Tachometer Adapter 6-25 HP (2S) 2002 MY Electric Start Models

Models Affected

MERCURY/MARINER
6 through 25HP (2 Stroke) Electric Start Models
Serial numbers : 0T409000 through 0T452251

59093

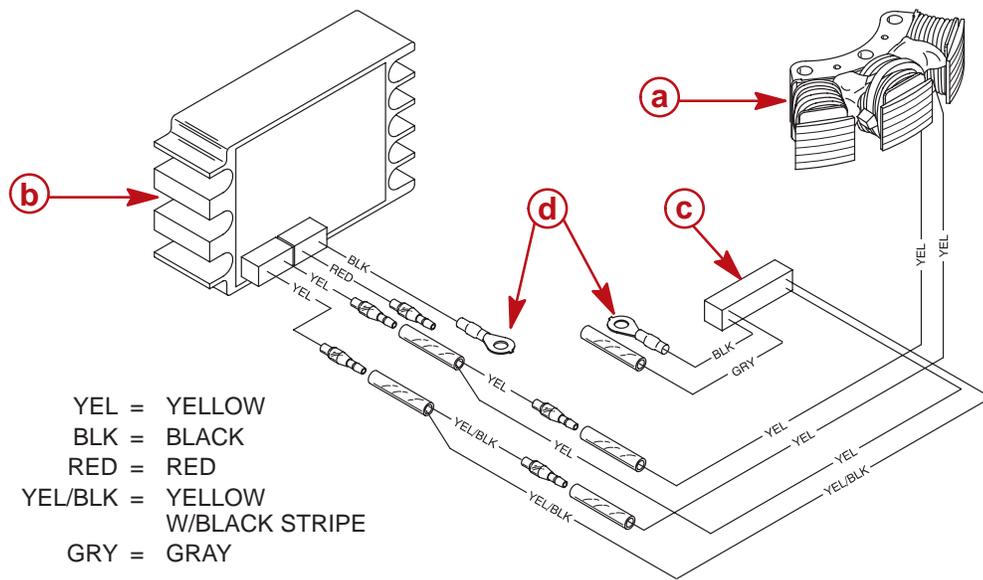
6 through 25HP (2 Stroke) electric start models received a change in the charging system for the 2002 model year product. The change is a regulated charging system utilizing a voltage regulator.

The voltage regulator, as supplied, does not properly drive a tachometer. Mercury Marine has developed an adapter. The adapter was added as a running change during the 2002 model year.

- a** - Stator
- b** - Voltage Regulator
- c** - Tachometer Adapter
- d** - Ground Connection at Crankcase Parting Line Area

All 2002 MY electric start models (6 through 25HP) within the serial number range listed above did not have an adapter as part of the engine. If there is a need to connect a tachometer to the engine, an adapter kit **MUST** be installed.

Quantity 1 of 17461T11 Tachometer Adapter Kit (if required)
